Realisation of ATC to Lelystad (EHLE) – independent review of project timelines (as of 6th February 2017)

This review of the project to introduce ATC services at Lelystad Airport is based on a request to look specifically at the schedule, and determine if the revised planning towards an April 2019 operational date is achievable, realistic and resilient.

Figure 3: Timelines for technical AAA system development

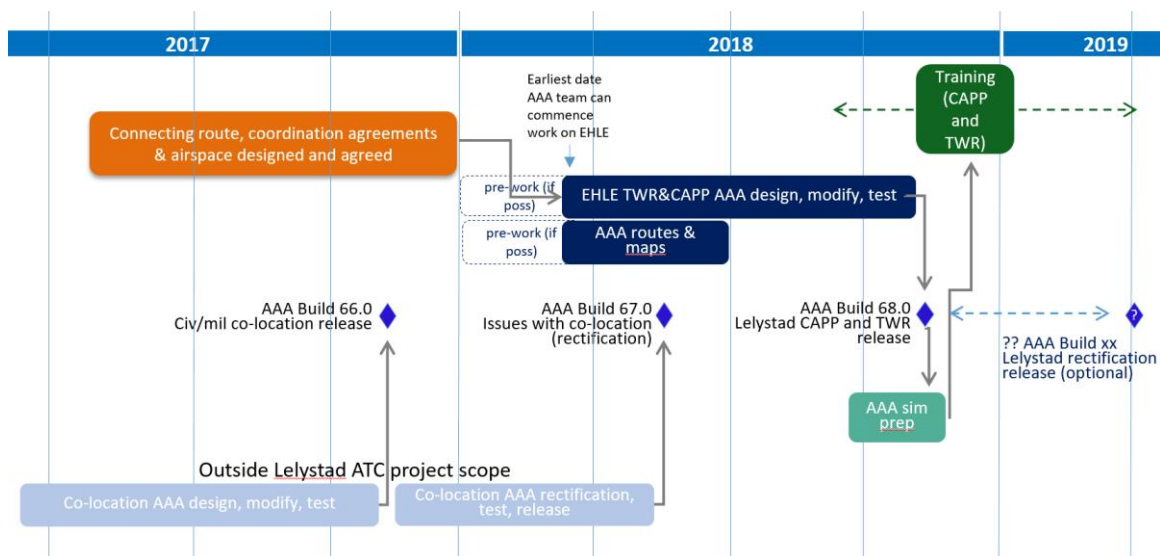
The AAA system development, including the build associated with the civil-military co-location project before this project, is on the critical path for the target date for operations at Lelystad (see Figure 3). The Lelystad ATC realisation project can be considered the customer for the AAA developments. Therefore, the risks associated with these projects are considered to be part of the overall system development and included within the project and steering groups. It should be tested whether control and decision making also fully sits with the relevant Steering Committee.

The planning for the AAA build calls for a delivery of Co-location AAA (66.0) by end of 2017, a single rectification build for Co-location AAA (67.0) six months later, and a delivery of Lelystad AAA CAPP and TWR (68.0) by November 2018. There are several smaller repair builds planned within these timelines. This schedule is then on the critical path for the simulator development and subsequent training, as shown in Figure 3.

A further risk lies in the planning for a single rectification release. In the review team's experience, a late change in requirements for controller acceptability can often occur, particularly when dealing with multiple stakeholders. A second rectification release may be required to address these; the scenario and planning for this should be assessed to understand what risk it would pose to the schedule for Lelystad ATC.

The review team questioned whether the lack of a rectification build for AAA Lelystad CAPP and TWR is justifiable in terms of experience, recent history and best practice. If a rectification build were required, it would almost certainly push back the operational date. There would be operational restrictions, due to less automation, more handwork and more verbal communication between TWR and CAPP.

- the planned start on Lelystad CAPP and TWR (~Mar 2018) is at significant risk from the co-location rectification build (due for release May 2018) and other projects across LVNL using software team resource; the plan appears vulnerable at this point;

- the lack of a rectification build for Lelystad AAA CAPP and TWR in the core planning is a concern; the review team recognises that the next step on the critical path (simulator and training exercise development and implementation) could proceed with the initial build, but also notes that any changes could require re-work and re-training;

2. In all aspects of AAA development, there is no margin in the planning. For true confidence in the schedule, LVNL could explore adding more margin, potentially planning for a second rectification build of AAA CAPP (co-location) and/or a single rectification build of AAA Lelystad CAPP and TWR. (**Internal** recommendation)

Figure 4: Project timelines and critical path (version 1: LVNL)

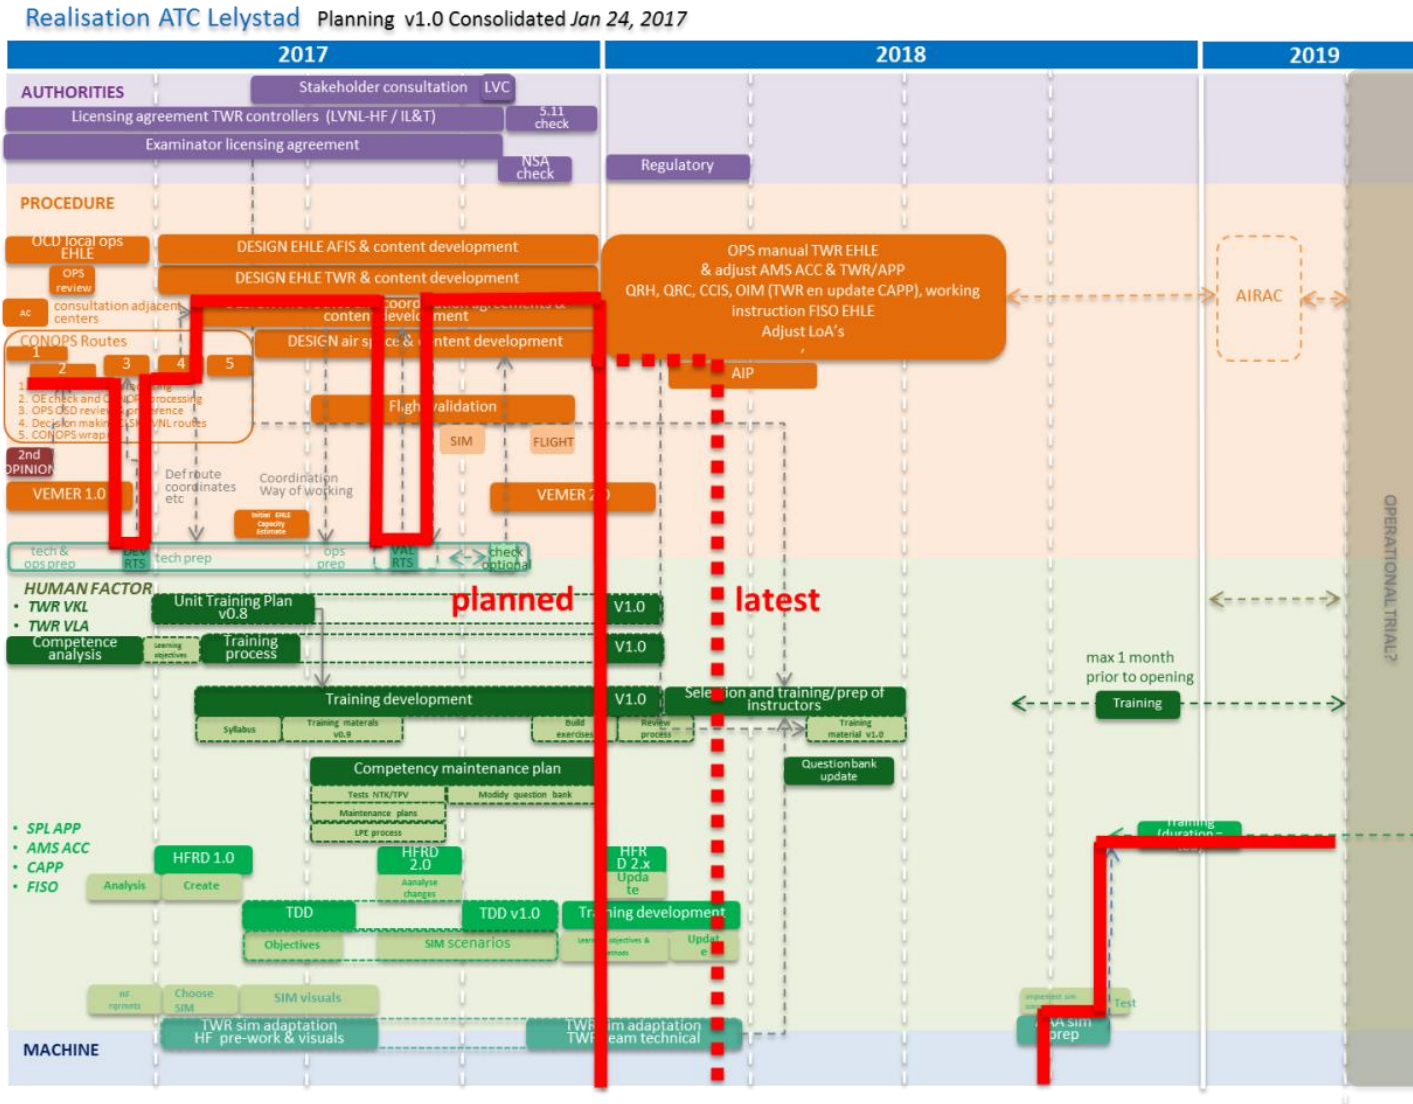
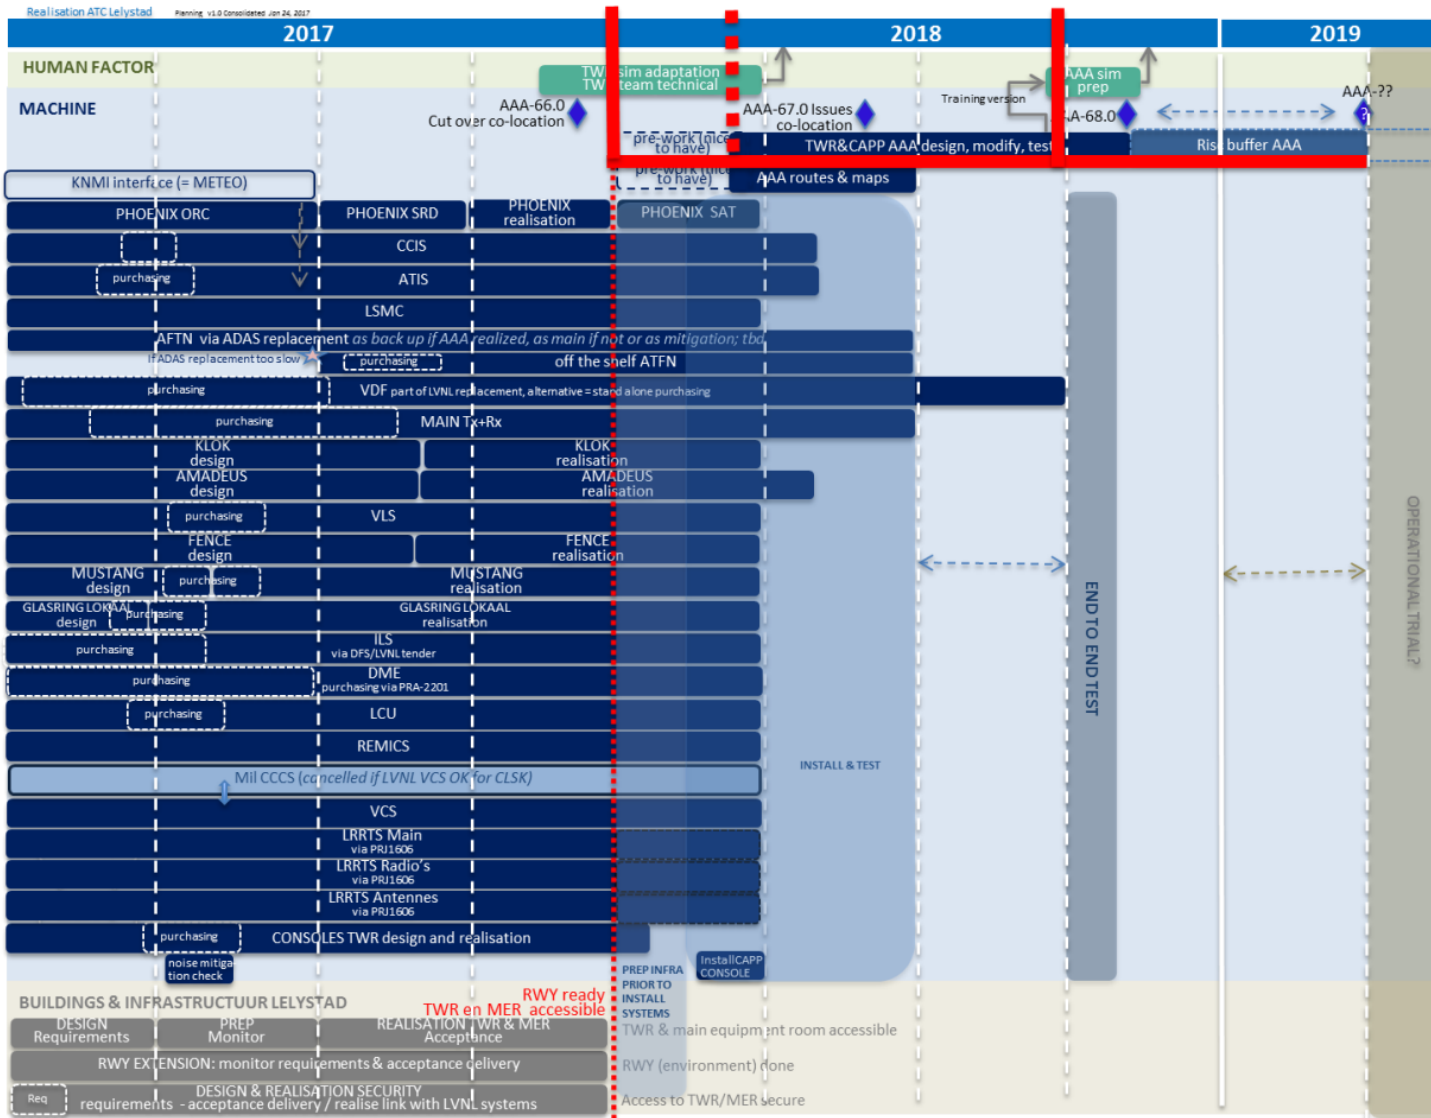
The core of the change process is overseen by the project management tasks across the lifecycle of the change. The planned schedule is captured in the Gantt chart in Figure 4, section 6, and the planning process and detail can be tested to give confidence that the critical path identified will be followed.

There has been an additional Real Time Simulation (RTS2) recently added to the schedule with a proposal for another. This back-up RTS would also lie on the critical path. RTS2 is still to be precisely scheduled, but is planned to be prior to October 2017. It may pose issues for availability of operational staff, particularly as the co-location project is also proposing to use simulator time during this period. Schedules are being closely monitored and planned between the Lelystad ATC project manager and military lead.

Consensus between LVNL and CLSK on the concept design is planned for May 2017, taking account of the LVNL workload modelling, MME modelling, and the RTS1 results. This then allows a range of other steps reliant on the concept design to begin, including formal procedure design, flight validation, stakeholder consultation and training design. This critical connected step is a high concern for the timeline.

However, some elements have been added towards the end of 2016 which may suggest a more generalised planning issue. As earlier discussed, the complexity of the project requires a high degree of forward planning for the procedure design,

AAA build and subsequent simulation and training steps. There is a project plan for the definition phase (signed in October 2015). The realisation phase plan completion was postponed due to the conclusion that the initial Lelystad project operational date (1 April 2018) could not be met. This has resulted in some elements added towards the end of 2016 (eg new simulations).

3. Develop risk scenarios to understand the potential impact of individual or combined risks on the operational date. From this process, ensure the externally agreed operational date takes reasonable account of possible future iterations of the project plan. Early identification of risk scenarios and therefore ensuring associated contingency in the project plan mitigates this risk. (**Internal** recommendation)
